## FINAL DESIGN SUBMISSION

National Capital Planning Commission  
06 April 2017

### *Smithsonian's National Zoological Park* Renew Bird House Facility - Experience Migration on Bird Plateau

## CFA and SHPO Comments and Responses

Metal Panel Details

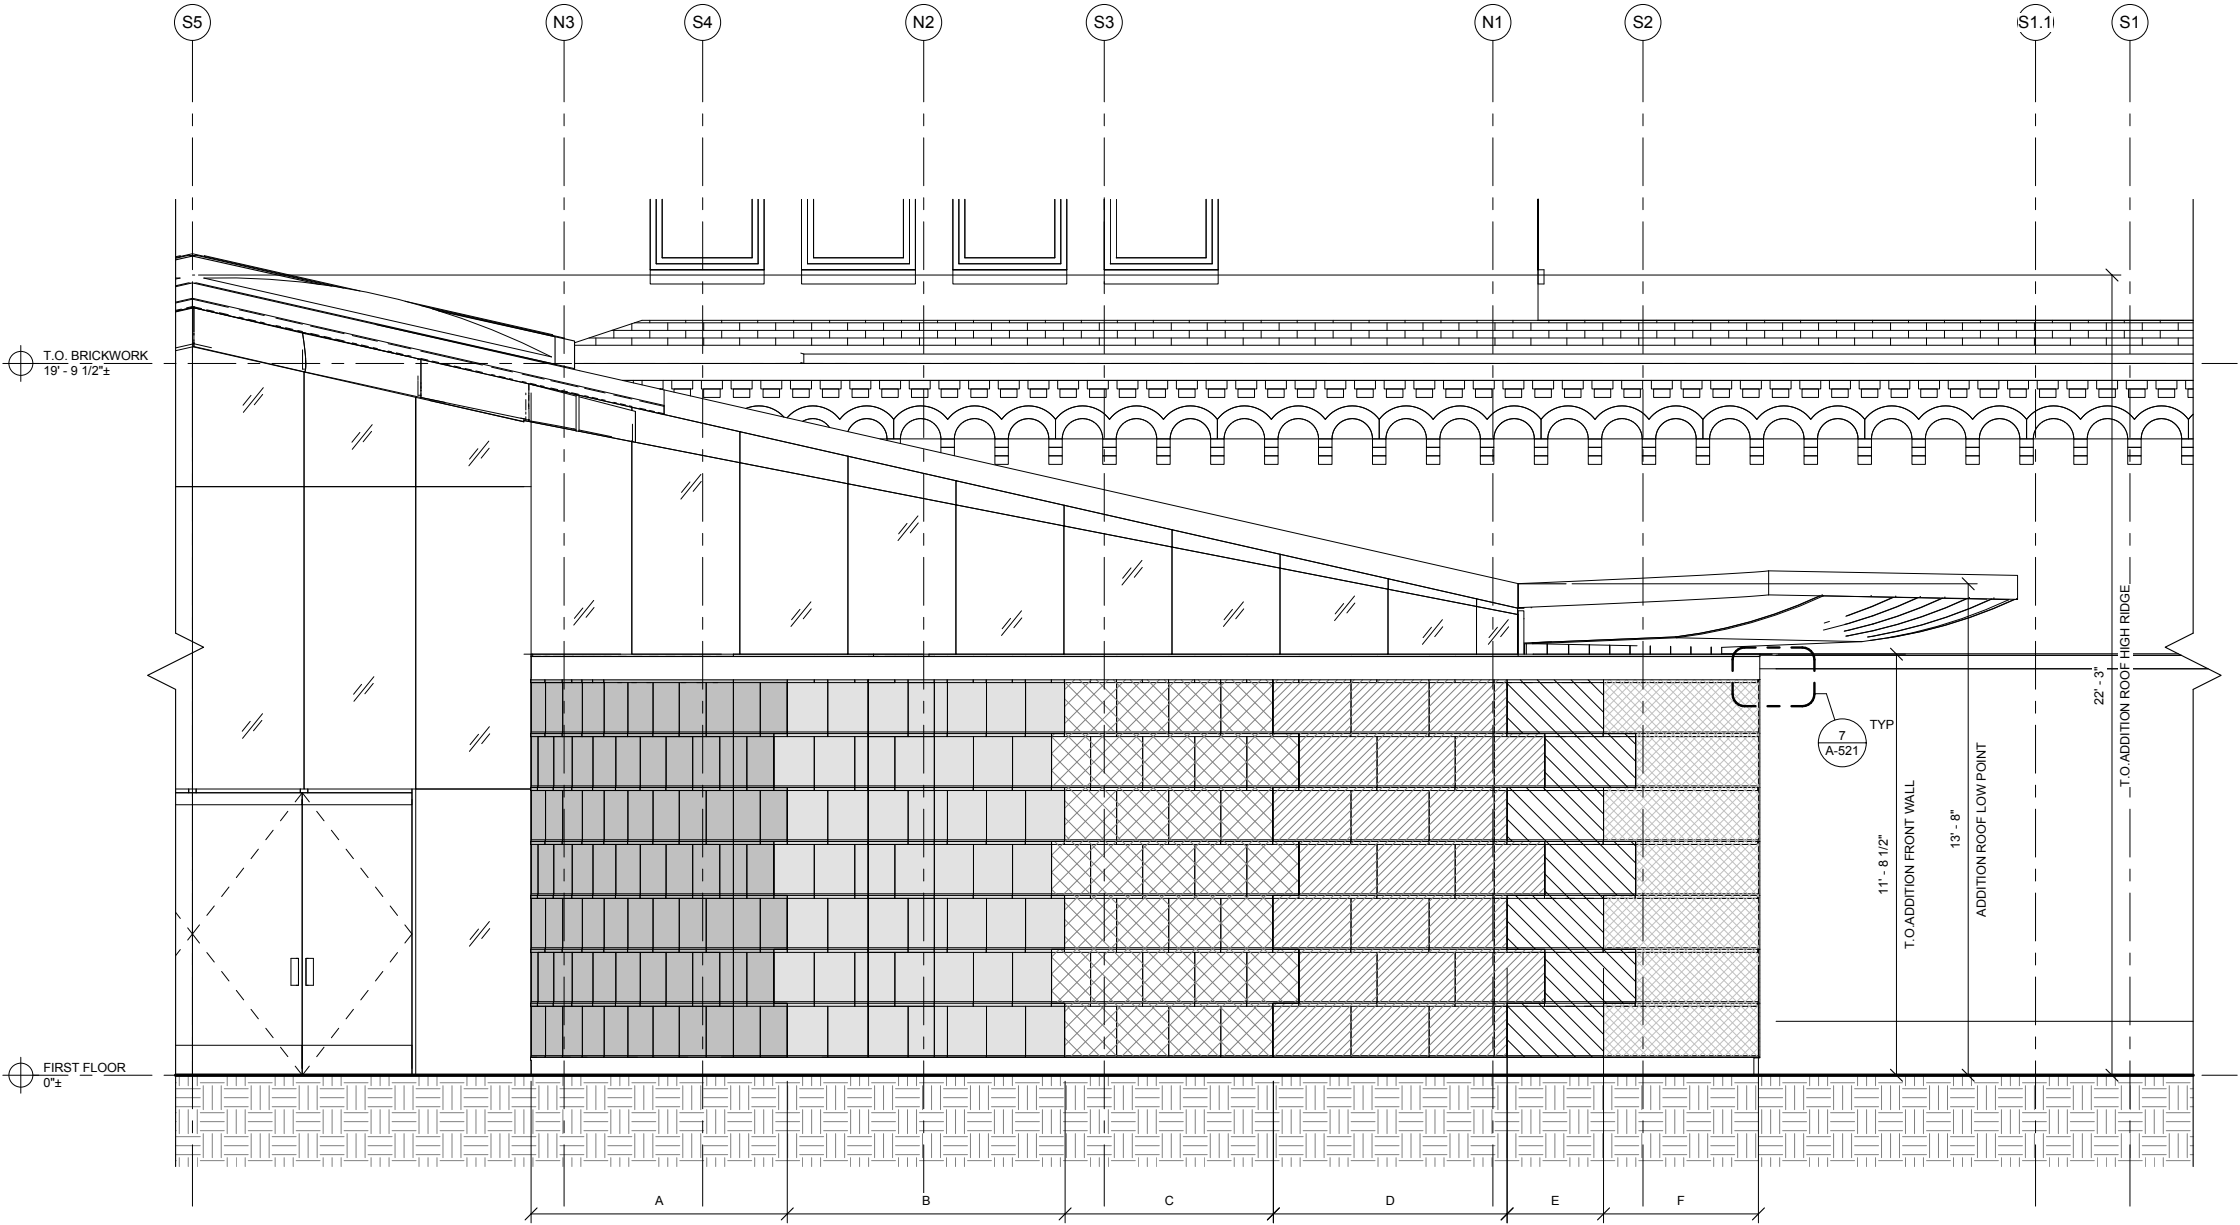
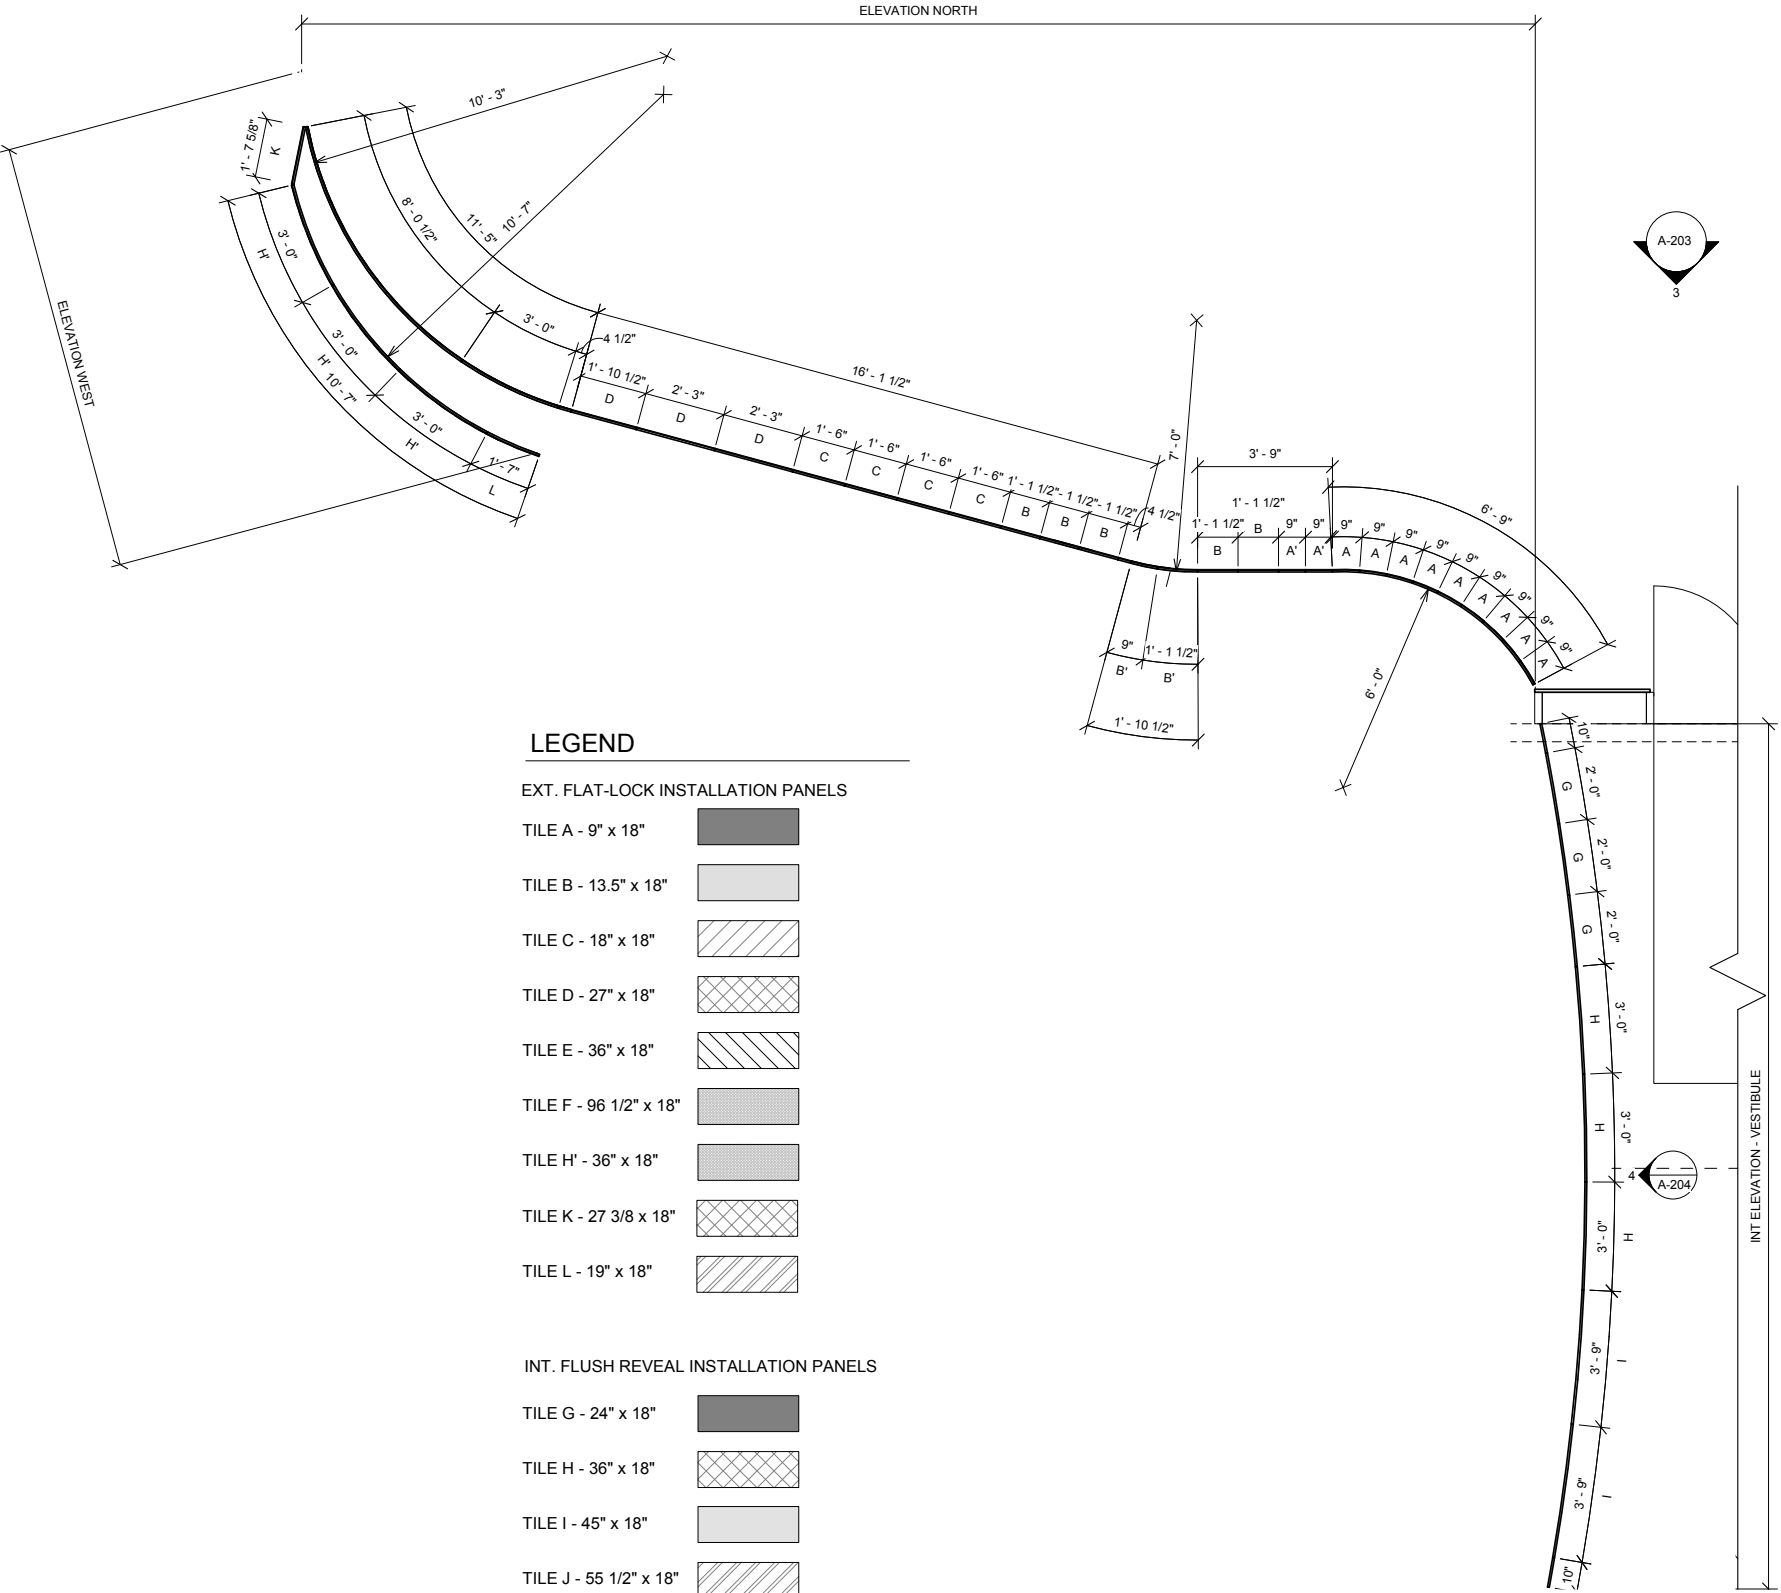
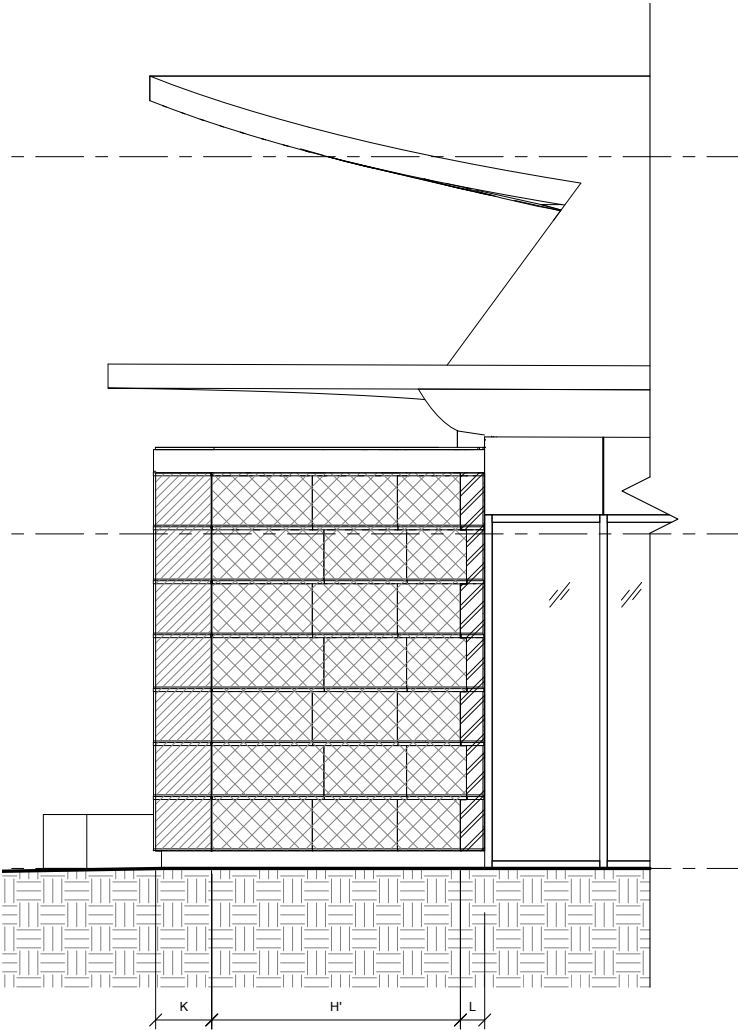
- "Shorten the extension of the ends of the bird feather front walls so ... therefore not aligned with roof...(Provide) details of this wall, end, exposed backside... (and) variation in panel colors and sizes." (CFA staff, Dec. 13, 2016)
  - *Design Team Response: New exterior renderings show the extents of the curved metal shingle walls pulled inward 16" at east and west. The cantilevered ends of the roof now extend beyond the walls, hovering. Additional construction and lighting integration details of the curved walls, including information about the variation in panel colors and sizes, have been included. (Jan 13, 2017)*

- "...endorsed the idea of plumage as the inspiration for the cladding of the entrance pavilion, emphasizing the need for appropriate detailing and a subtle variety of colors and shapes..." (CFA July 29, 2016)
  - *Design Team Response: Further design development and detailing of the metal panels system has been advanced and provided for review and comment. (Dec. 08, 2016) Page 41-43.*

### First Floor Plan - Addition of New Flue Enclosure

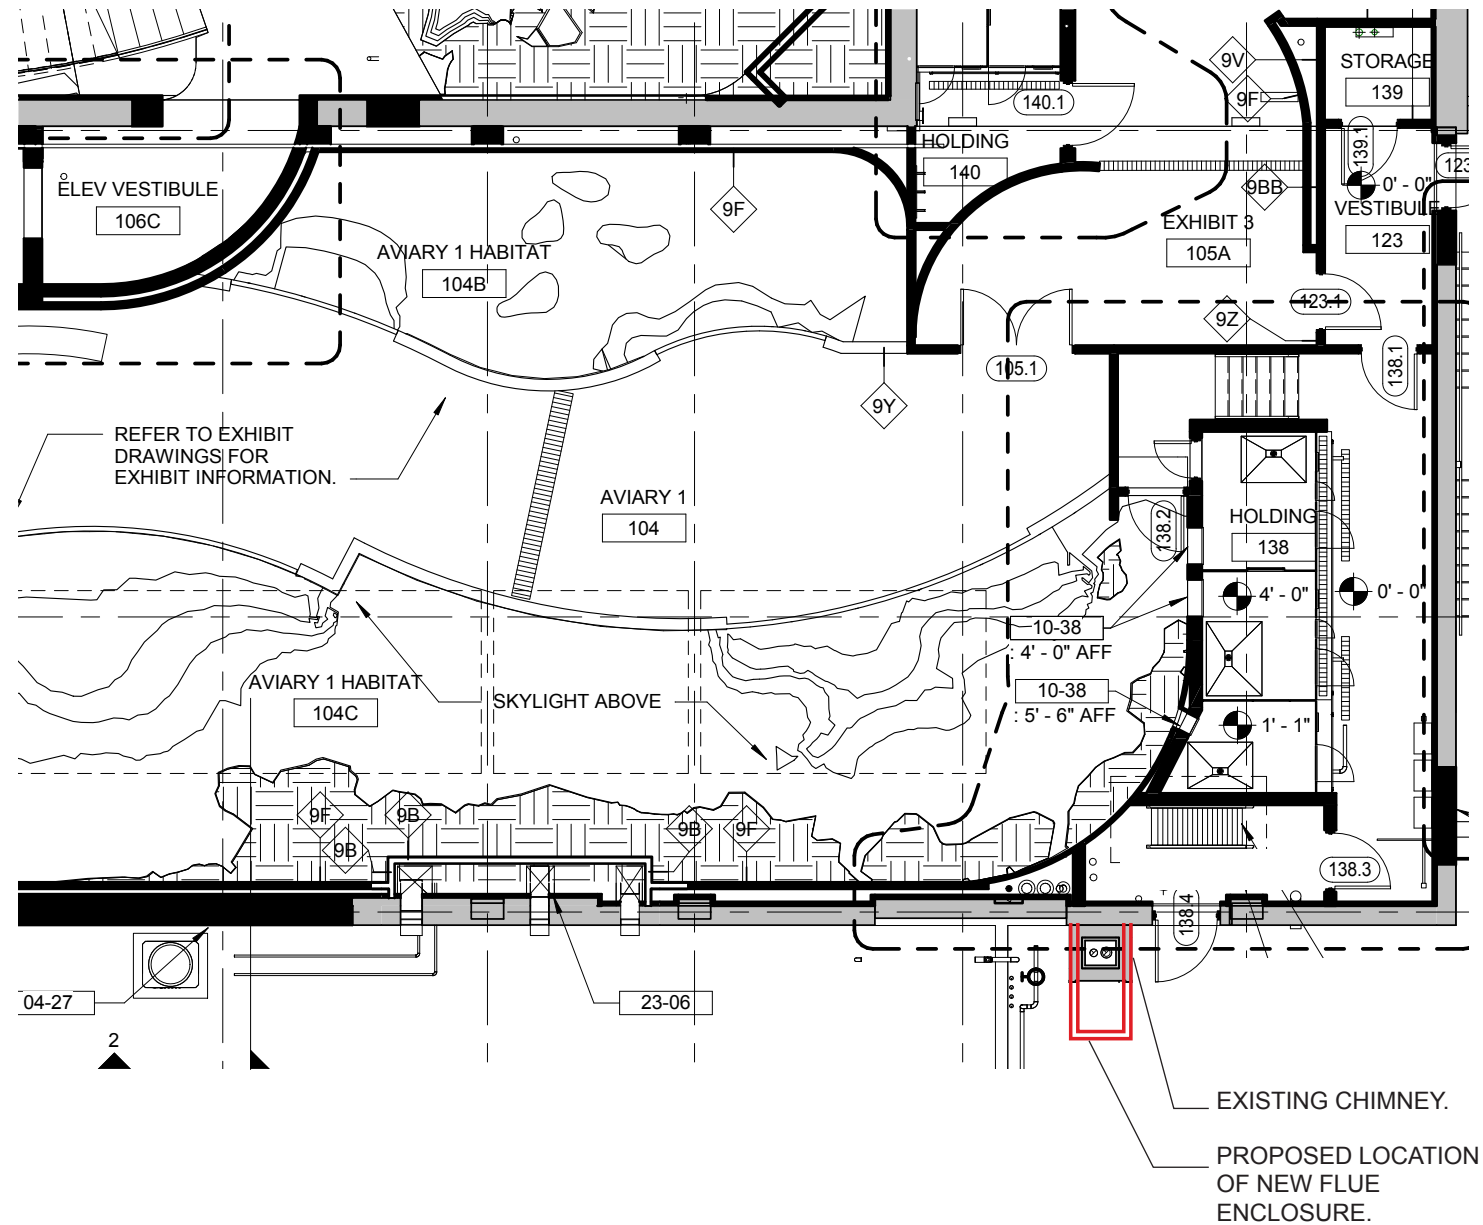
- Recent Mechanical modeling has introduced the need for more high-elevation exhaust at the back-of-house areas south of the facility. At that location, a late-20th century brick chimney is inadequate to enclose all of the required flues. Modifications will require a total footprint roughly twice that of the existing chimney, as indicated by mechanical calculations and shown in the attached diagrams.

- *Design Team Response: The design team anticipates developing detailing for a chimney with the following considerations:*
    - *No visual impact upon the primary public facility entrance at north;*

- *No impact to the historic decorative panel west of the existing chimney;*
    - *The top of the new chimney will align with the top of the existing one;*

- *Modern brick of sympathetic hue, coursing, and detailing with respect to the historic masonry will be considered for masonry options. (Jan. 13, 2017)*

- *Four concept options have been considered to address the additional mechanical exhaust on the south elevation of the building:*
    - *The preferred option adds a new brick masonry enclosure adjacent immediately south of the existing chimney. This additional chimney might be added to, or replace the existing chimney location. (Jan. 13, 2017)*

- "...concur that [the preferred chimney option] would be the most appropriate." (SHPO, Jan. 27, 2017)
- "We have no objections to the preferred option." (CFA staff, Feb. 1, 2017) Page 44.
